Reply to Office Action of July 14, 2004

Application No. 09/925,867

**Amendments to the Drawings:**

Fig. 3

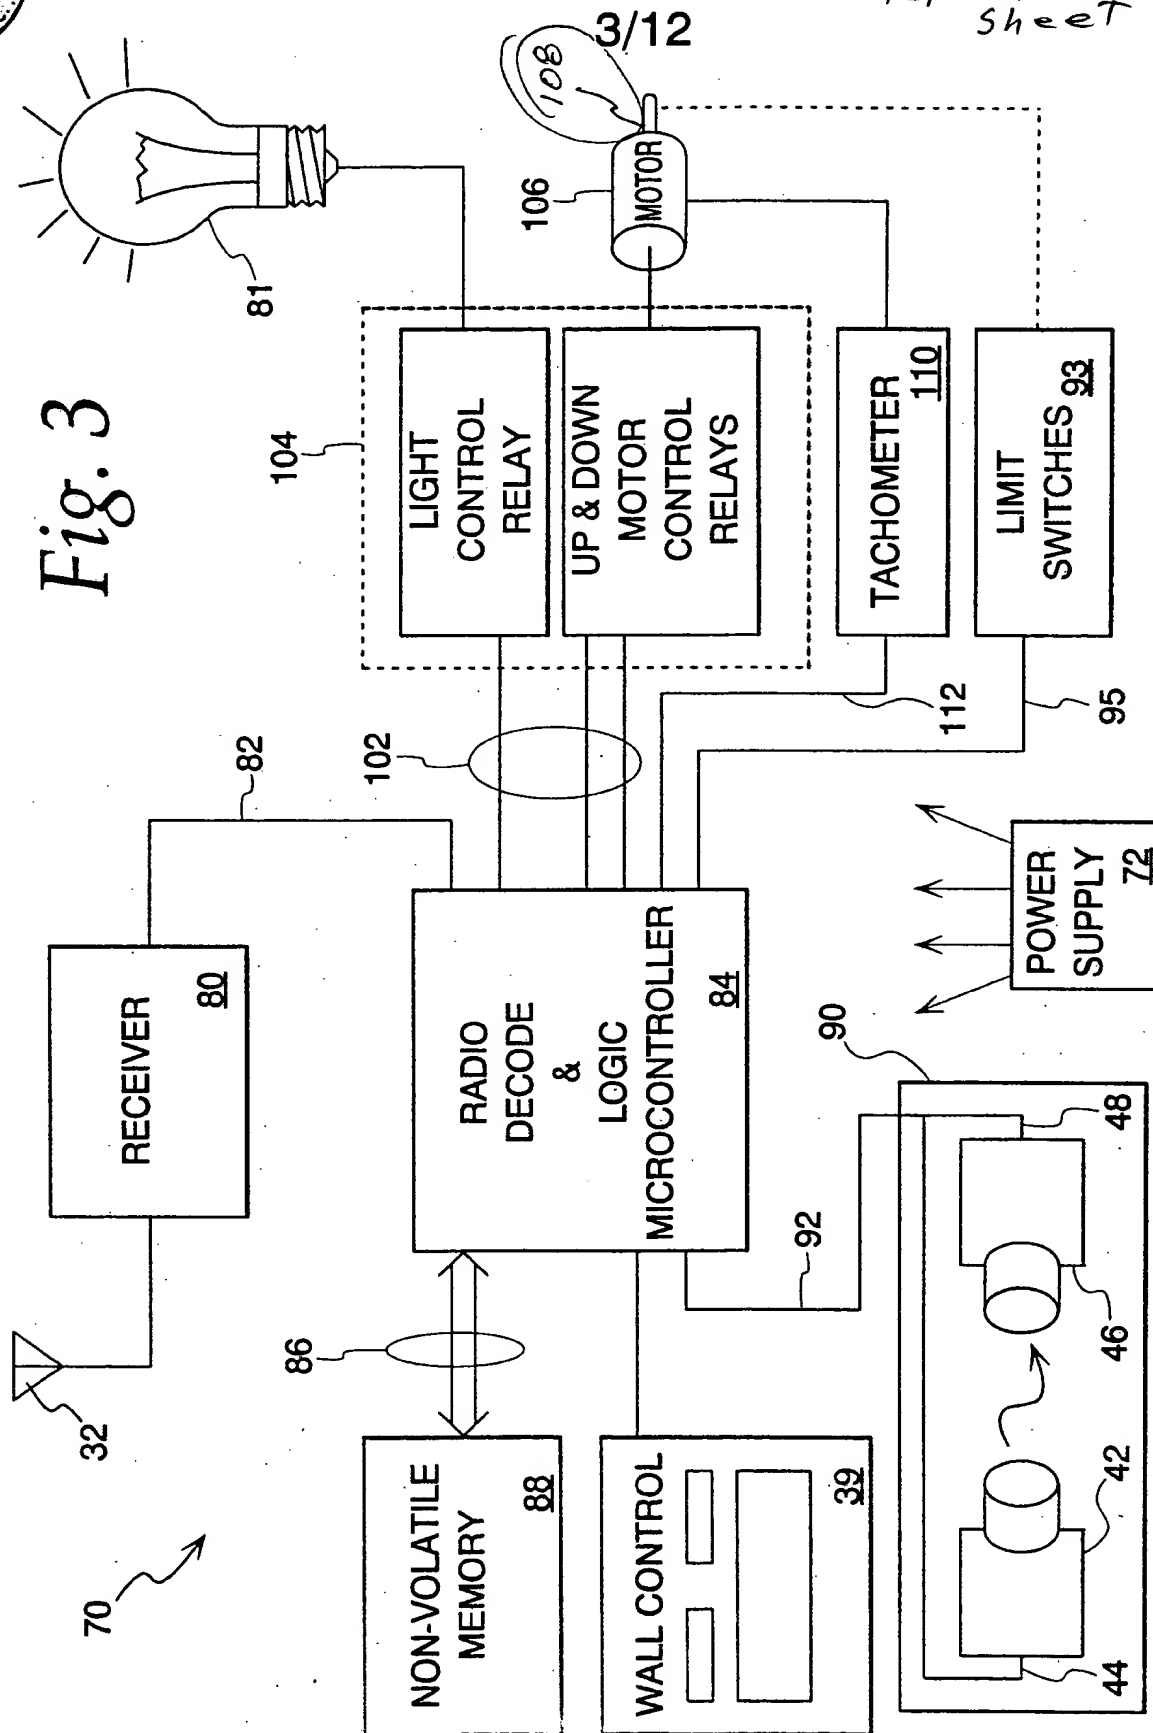
The drawing is also objected to as containing reference characters not shown in the text. The objection to Fig. 1 is corrected by adding the reference numeral 16 to page 5, line 12 of the text. The line 40 of Fig. 2 is referred to at page 5, line 33 of the text. The light 81 of Fig. 3 is already included at page 10, lines 22 and 23 of the text. Fig. 4 is being corrected to delete reference numerals 606, 623, 624 and 630. The lines 82 of Figs. 5 and 6A are already shown in the text at

A separate attachment includes a Request for Approval of Proposed Drawing changes of Figs. 3,4,6A and 8A.

6/12

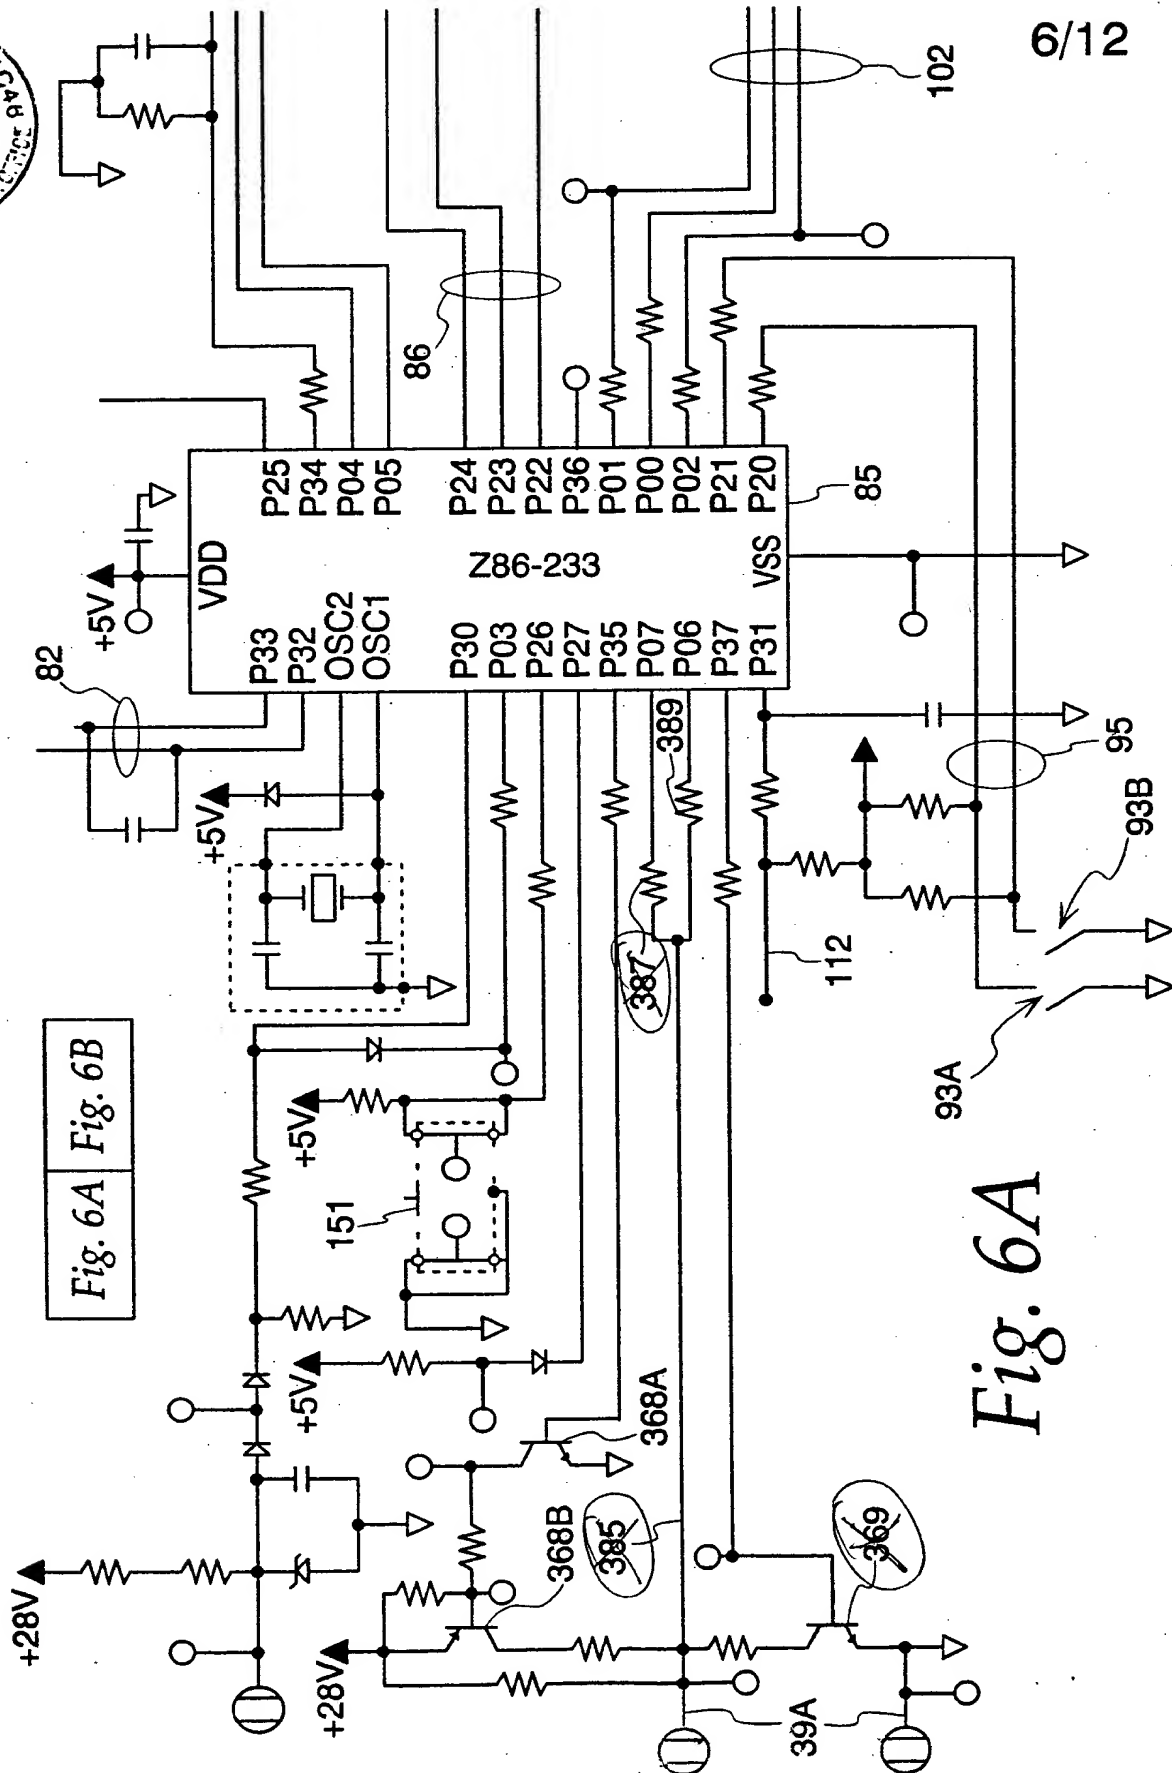
page 6, line 29. The reference characters 385, 387 and 369 are being removed from Fig. 6A and the relay logic line 102 of Fig. 6A is already discussed at page 6, line 38 of the text. The designation of step 502 is being added to page 8 of the text at line 17 and the reference numeral 508 is being removed from Fig. 8A. Lastly, the second reference character 544 appearing at page 9, line 12 of the text is being changed to 543. Applicant believes that the above noted changes to the text and drawings correct all situations objected to in the drawing by the Examiner.
